USB PD CTS ENGINEERING CHANGE NOTIFICATION FORM

Title: tSenderResponse timeout test procedure update
Applied to: USB PD CTS Q1, 2026 OR

Timing update per USB PD R3.2, V1.2 update.

Illustration from USB PD R3.2 V1.1 ECN HardReset_processing_time_clarification:

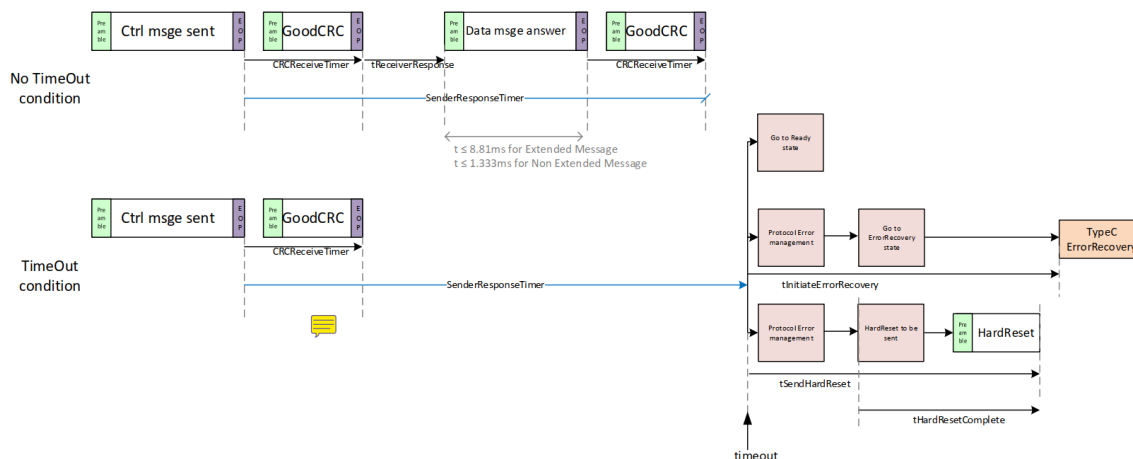
Illustration of the clarification:

Note: Correction on SenderResponseTimer to start from the end of GoodCRC(discussed 3/25 in CTS call)

What for ?	Min (ms)	Max (ms)
CRCReceiveTimer (tReceive)	Timeout	0.9	1.1
SenderResponseTimer(tSenderResponse)	Timeout	27	50
VDMResponseTimer (tVDMSenderResponse)	Timeout	24	50
tReceiverResponse	Max time to send response	-	15
tHardResetComplete	Max time to send message	4	5
tSendHardReset	Max time to send message		15
tInitiateErrorRecovery	Max time to ErrorRecovery		15
